Bass Coast Amendment C152 – Wonthaggi North East

Changes Report

May 2022

Figure 2 - Concept Plan for 35 Carneys Road presented in VPA/Bass Coast Closing Submission

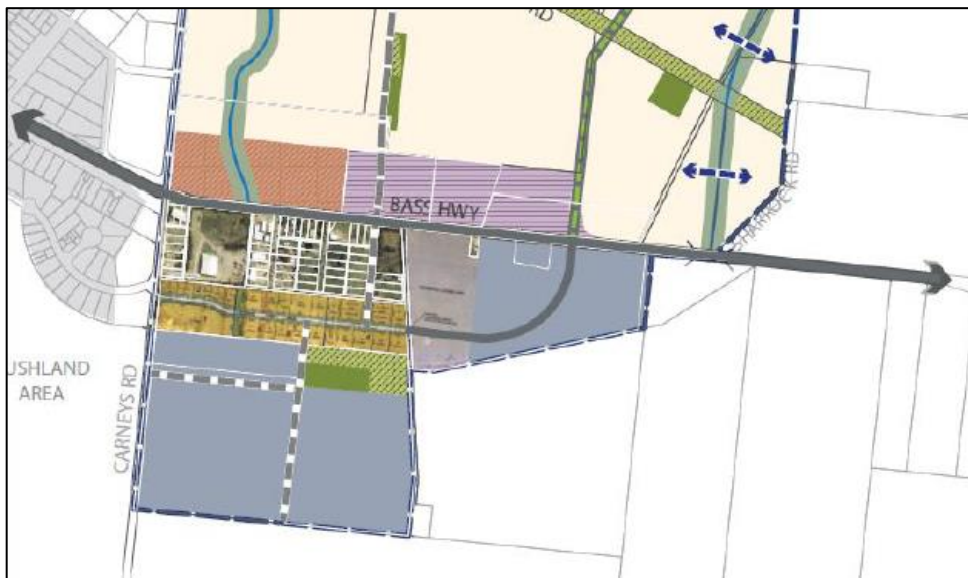
This change relates to the location of St Clair Boulevard as shown within 35 Carneys Road (PSP Property 127), raised by submitter 23. The submitter requested the east-west connector road shown along the southern boundary of the property be shifted north, approximately in the centre of the property to reflect the road layout approved in a Development Plan for the site.

The VPA and Council agree with submitter 23 in relation to the location of St Clair Boulevard on its land and will amend the PSP to reflect and be consistent with the road layout approved in the 35 Carneys Road Development Plan. Specifically, this requires shifting St Clair Boulevard to the north to align with the road shown in the Development Plan, as identified below:

Figure 3 - Revised Location of St Clair Boulevard through 35 Carneys Road

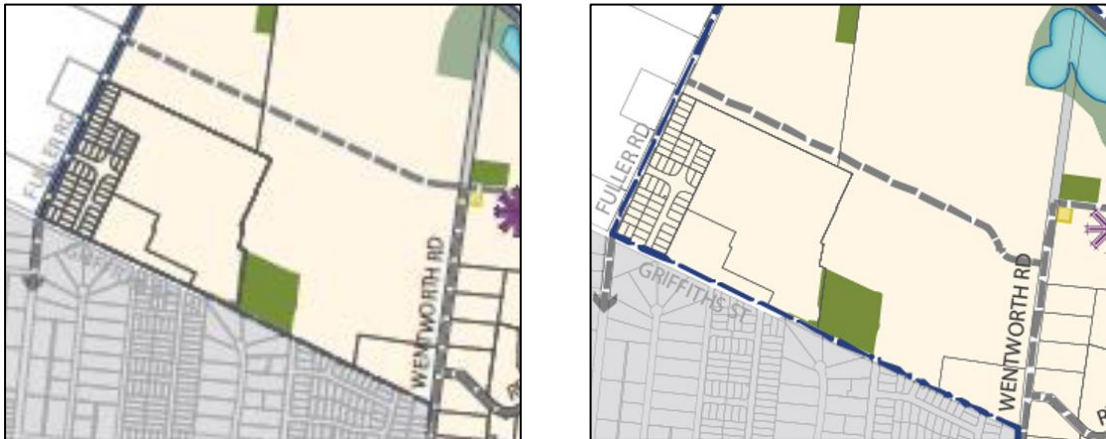
The VPA has updated the November 2021 PSP to include this change, as shown in Figure 3. It is noted that the north-south access street (industrial) emanating from St Clair Boulevard has also been extended north to maintain connectivity. The change has been implemented as stated in the closing submission as it is a better reflection of the expected development of the site and nearby properties owing to the approved Development Plan on the site, and is therefore relevant for inclusion.

Figure 5 - Excerpt of Plan from Closing Submission showing realigned eastern waterway and Mixed Use rezoning

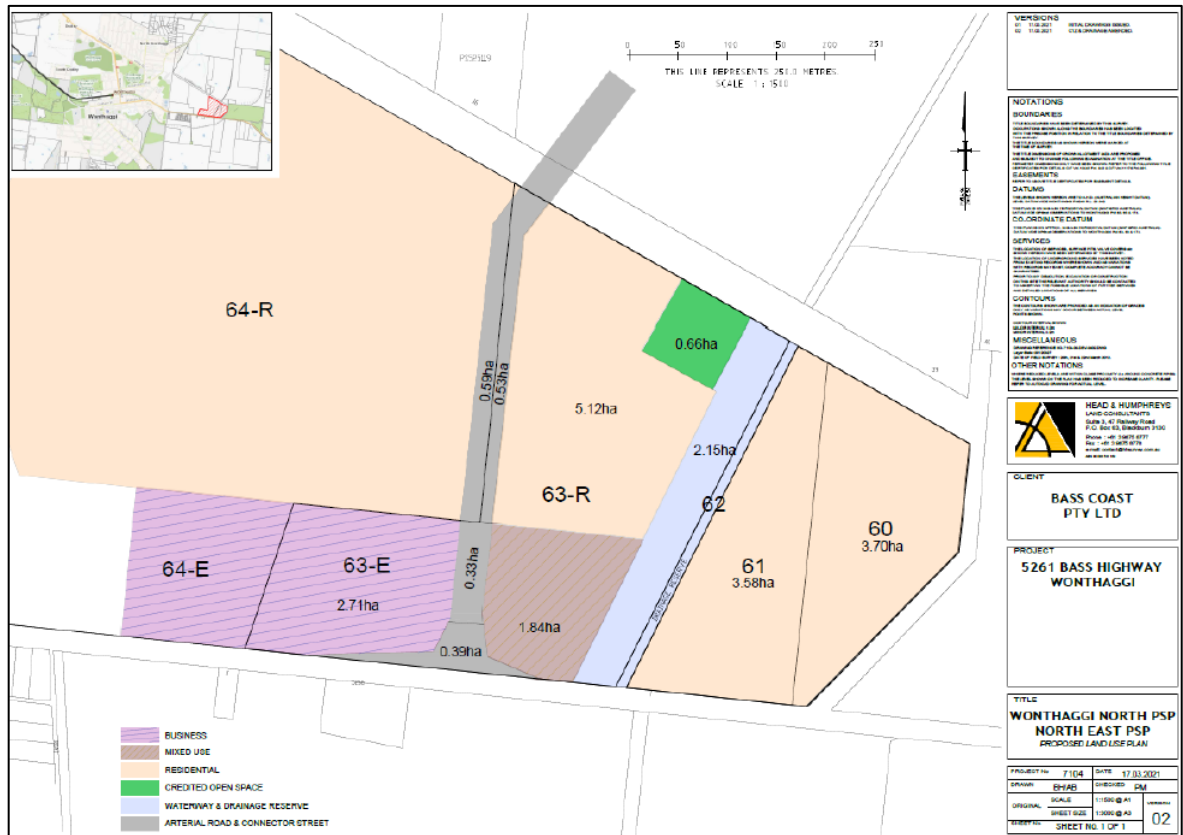
- the depth of the C2Z land be 90 metres;
- the MUZ be extended eastwards, as identified below; and
- it will support the realignment of the drainage corridor, subject to approval from DELWP and any investigations as part of the further drainage work undertaken as part of Tranche 2. (The VPA and Council note that the drainage corridor is Crown land and that shifting the drainage will impact on the existing culvert location and shorten the pipe south of the culvert.)

The above position is illustrated in the following plan:

The Future Urban Structure Plan has been updated to realign the waterway onto the crown land and accommodate the Mixed Use Zone (MUZ). The VPA received confirmation from DELWP that the realignment of the waterway onto crown land was supported.

Figure 6 - Future Urban Structure Comparison for Submitter 10 Changes

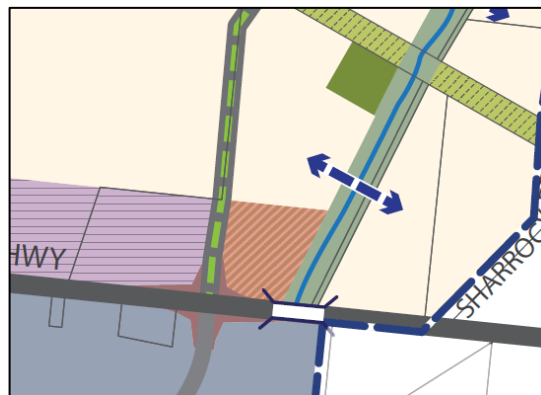
However, during the Tranche 1 hearing, Submitter 10 changed their position and requested the land to the east of the intersection be rezoned to MUZ instead of the CZ2. If the 90m depth of the CZ2 land were to be retained, this would result in a net loss of CZ2 land, contradicting the recommendations of the *Commercial and Industrial Land Assessment* (prepared by Urban Enterprise, 2017) that recommended 8 hectares of CZ2 land be provided within the PSP. Therefore, when making these changes, the depth of the CZ2 land has been retained. It is also noted that the above plan that was prepared by Submitter 10 and included in the VPA and Council's closing submission did show the Commercial land at a depth of 90m.

The exhibited and November 2021 PSP versions demonstrating the implemented changes are shown in Figure 6.

Figure 7 - Cross Section 15

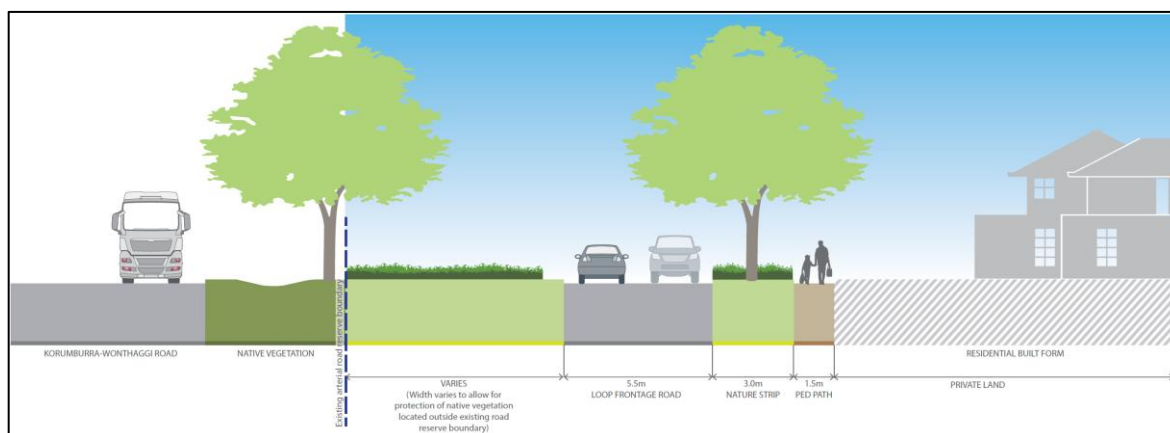
A new cross section showing services roads on both sides should be added to the PSP to apply to the Korumburra-Wonthaggi Road interface with abutting residential areas.

This cross section has been added to the November 2021 PSP and is identified as Cross Section 15. The cross section depicts Korumburra-Wonthaggi Road and the service road interface it will have with residential areas. Plan 9 (Road Network) has also been updated to reference the new cross section. An excerpt of the cross section is provided in Figure 7. It is noted that DoT were consulted on the cross-section prior to its inclusion into the November 2021 PSP and provided support for its design.

Figure 8 - Excerpt of Open Space Plan

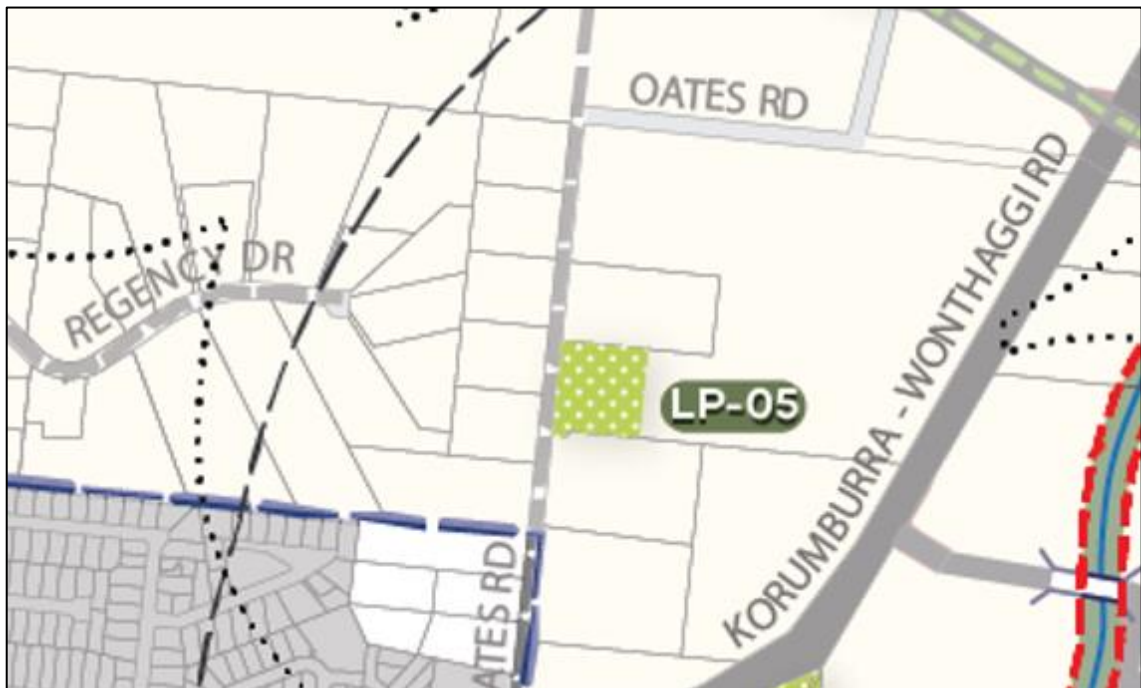
The PSP Plan 6 (Open Space) should be amended to move open space LP-05 south along Oates Road from its current position to a location immediately south of property parcel 41.

The Open Space Plan in the November 2021 PSP (now Plan 7) has been amended to relocate LP-05 in the described location. This change is shown in an excerpt of Plan 7 in Figure 8 below. This change has no impact on the Land Use Budget for PSP Property 40 as the total area of the park on the land remains the same.

3.1.1 Outfall drainage culverts

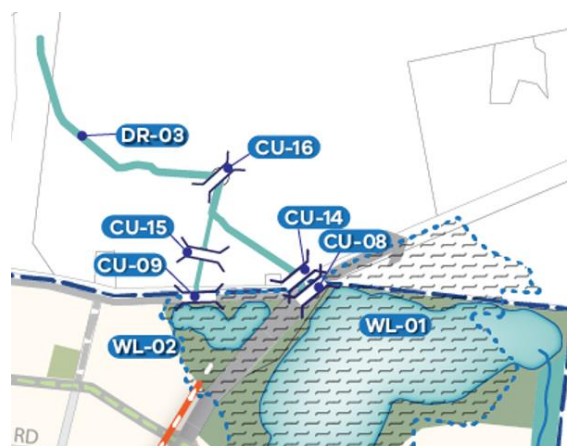
Cardno Victoria Pty Ltd (Cardno) prepared concept design and high-level costing for three crossings spanning east-west across the main outfall channels. The crossings are required for the landowner to be able to access the other paddocks within property once the channels are upgraded to accommodate drainage outfalls from the PSP. Cardno's concept design drawing set and cost estimates will be included as transport construction items in the DCP (i.e. CU-14, CU-15 and CU-16).

Removal of CU-011

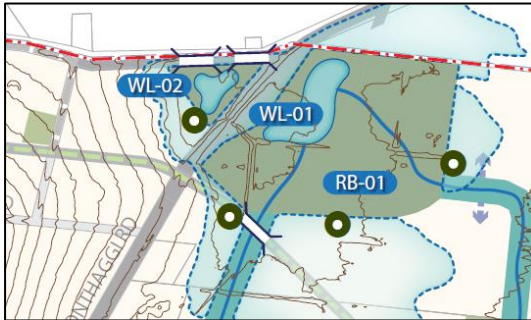
CU-011 has been removed from the PSP as Alluvium has not identified this asset as part of the functional drainage layout.

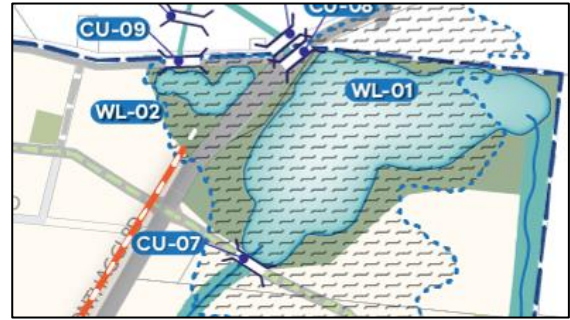
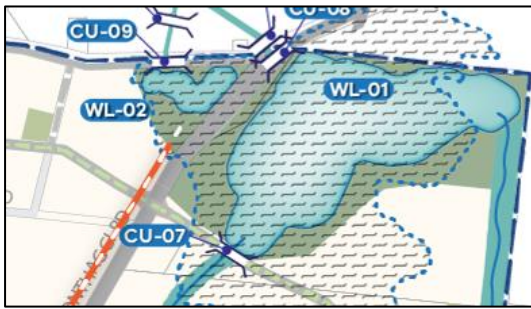
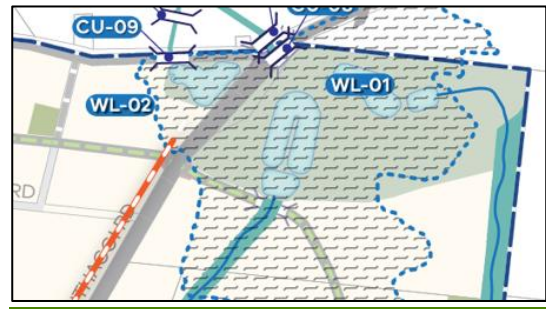
Following from recommendations put forward by the Preliminary Drainage Review, Alluvium has reduced the macrophyte zones of WL-01.

Wetland 2

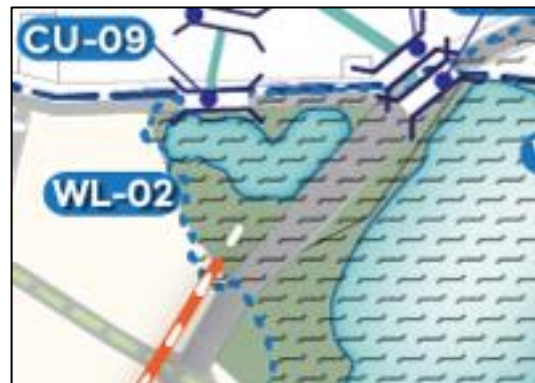
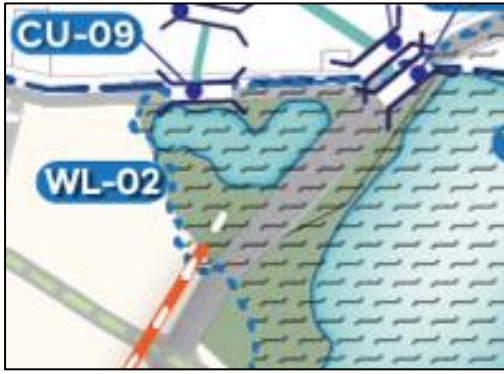
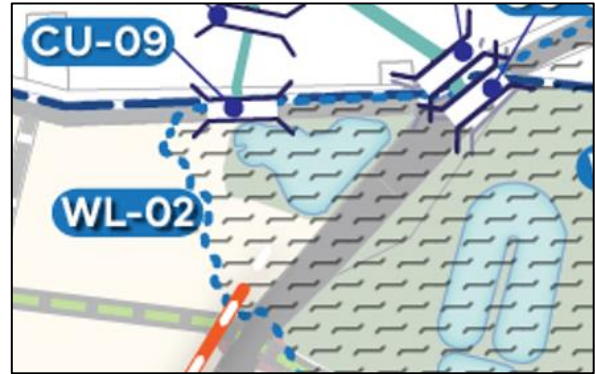
The layout and design of wetland 2 has been further refined to ensure performance of the treatment system complies with appropriate guidelines. Below is a comparison of the asset footprint.

Following from recommendations put forward by the Preliminary Drainage Review, Alluvium has reduced the macrophyte zones of WL-02.

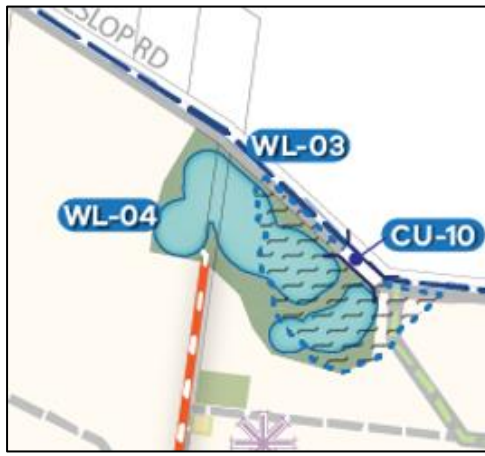
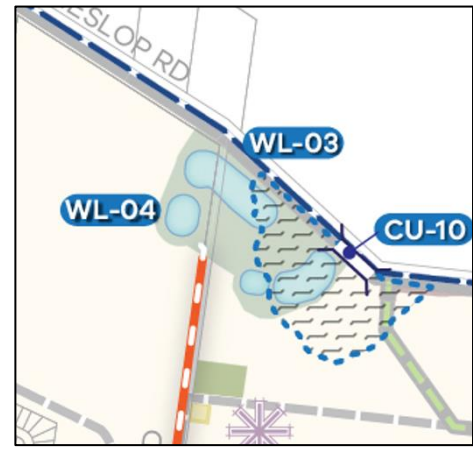
Following from recommendations put forward by the Preliminary Drainage Review, Alluvium has reduced the macrophyte zones of WL-03. WL-04 remains unchanged as the asset footprint is approved in an existing development plan.

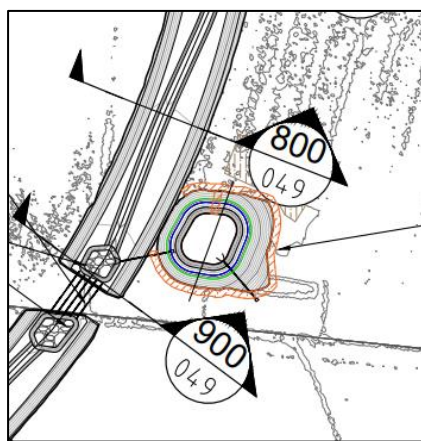
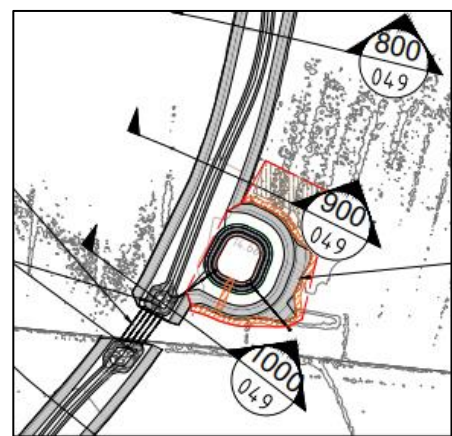
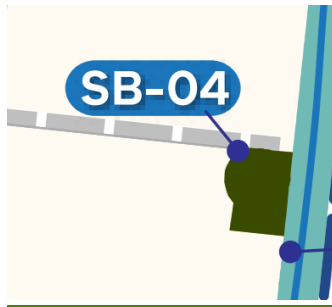
Following the Preliminary Drainage Review, SB-02 and SB-04 have been relocated into the waterway corridor of DR-01 and DR-02 respectively. The rationale for this was to reduce land take, earthworks and plantings. The designs still satisfy the necessary velocity and maintenance criteria.

Figure 9 - Proposed boulevard connector and intersection alignment, accounting for WL-01 footprint

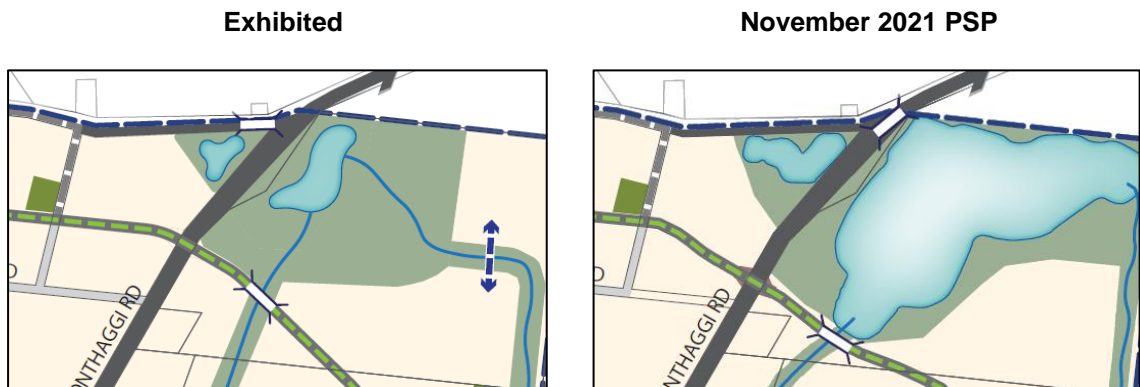
As the footprint of WL-01 had been modified, the boulevard connector road and Korumburra-Wonthaggi Road/boulevard connector intersection has been shifted to avoid conflict with the new wetland footprint (See Figure 9).

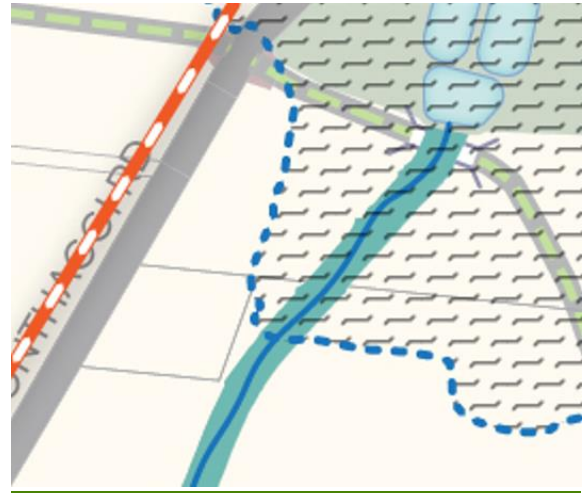
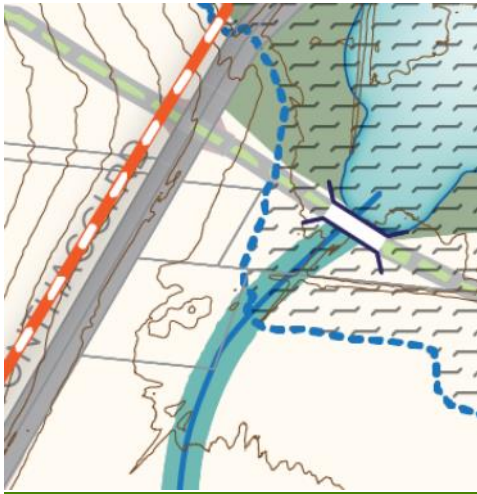
In response to submissions, the connector street aligned has been shifted to facilitate a better road connection, noting that the generally in accordance principle applies at more detailed planning stages.

3.2.0 IN-01 consideration of water main

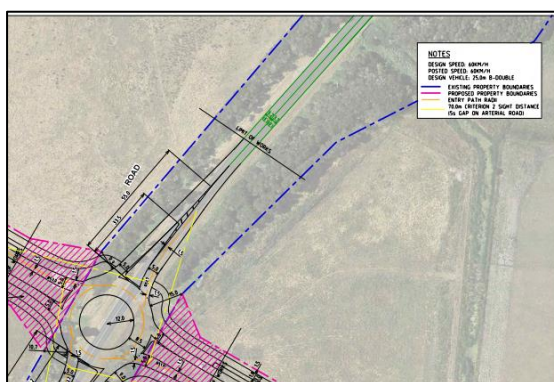
South Gippsland Water advised that there is an existing water main located on the southern side of Heslop Road that crosses Fuller Road on the southern side of IN-01. To avoid relocating the existing South Gippsland Water asset within the Fuller Road Road reserve, the future Fuller Road carriageway may need to be realigned east of the existing road reserve. This does not result in a PSP change as more detailed investigations will be undertaken at the functional design stage, however a note has been included in the concept drawing for IN-01 to investigate further.

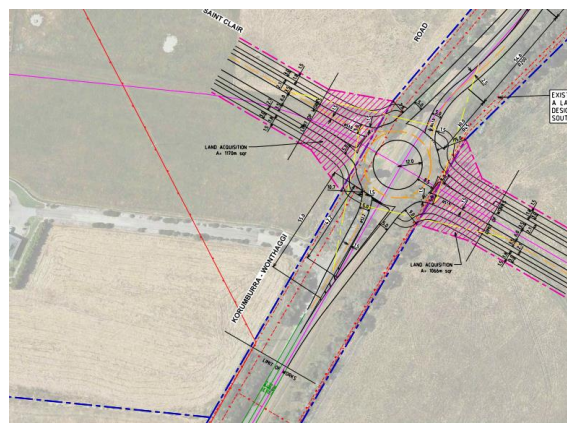
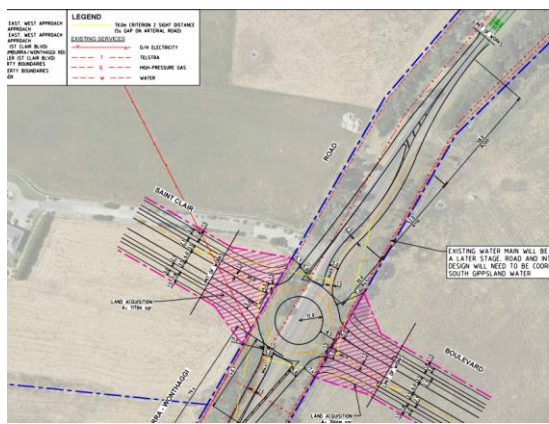
In March 2022, designs and costs for IN-04 based on the location required to accommodate the increased footprint of WL-01 were prepared. However, as further redesign of WL-01 has resulted in a reduced wetland footprint, IN-04 has been returned to the design and cost estimate provided in Transport Impact Assessment (Stantec, November 2021).

Figure 11 - Excerpts of Plans 2 and 12 showing gas pipeline and relevant buffer distances

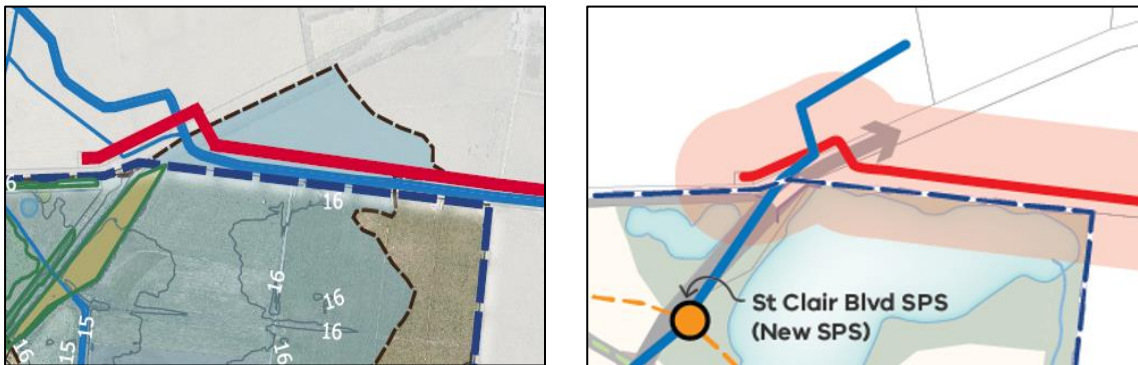
Plan 2 – Precinct Features and Plan 12 – Utilities have been updated to depict the transmission pressure gas pipeline, with Plan 12 also depicting the measurement length identified in the SMS (143m). The identification of the measurement length is important for the implementation of objectives, guidelines and provisions in the PSP and ordinance to appropriately manage safety with respect to the pipeline.

Excerpts of Plans 2 and 12 showing the pipeline and relevant buffer distances are shown below.

Figure 12 - LP-12 Redistribution

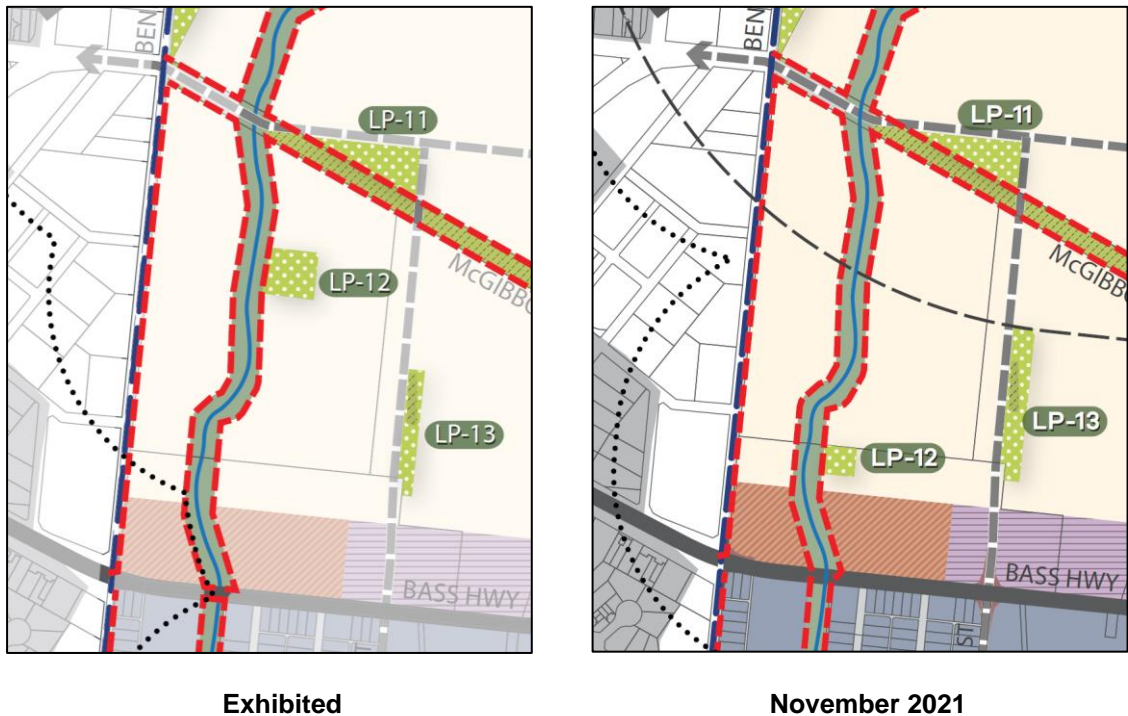
LP-12 (0.83ha local park) was redistributed from PSP Property 65, with LP-12 now consisting of a 0.34ha park in PSP Property ID 66-R, and with LP-13 on PSP Property 64-R increasing from 0.51ha to 1ha (extending further north). This change was made in response to a planning permit for subdivision that is approved on Property 65 which did not include a local park. This was raised by submitter 31 (submission was located late and circulated as part of re-notification on November 2021). Therefore, in order to ensure there was no net loss of open space in the area, the area of the park was redistributed across adjoining properties to preserve the walkable catchment of local parks within the PSP. The changes are reflected in the November 2021 PSP, excerpted and compared with the exhibited version identified in Figure 12. The change also results to amendments to the Land Use Budget for PSP Properties 64-R, 65 and 66-R.
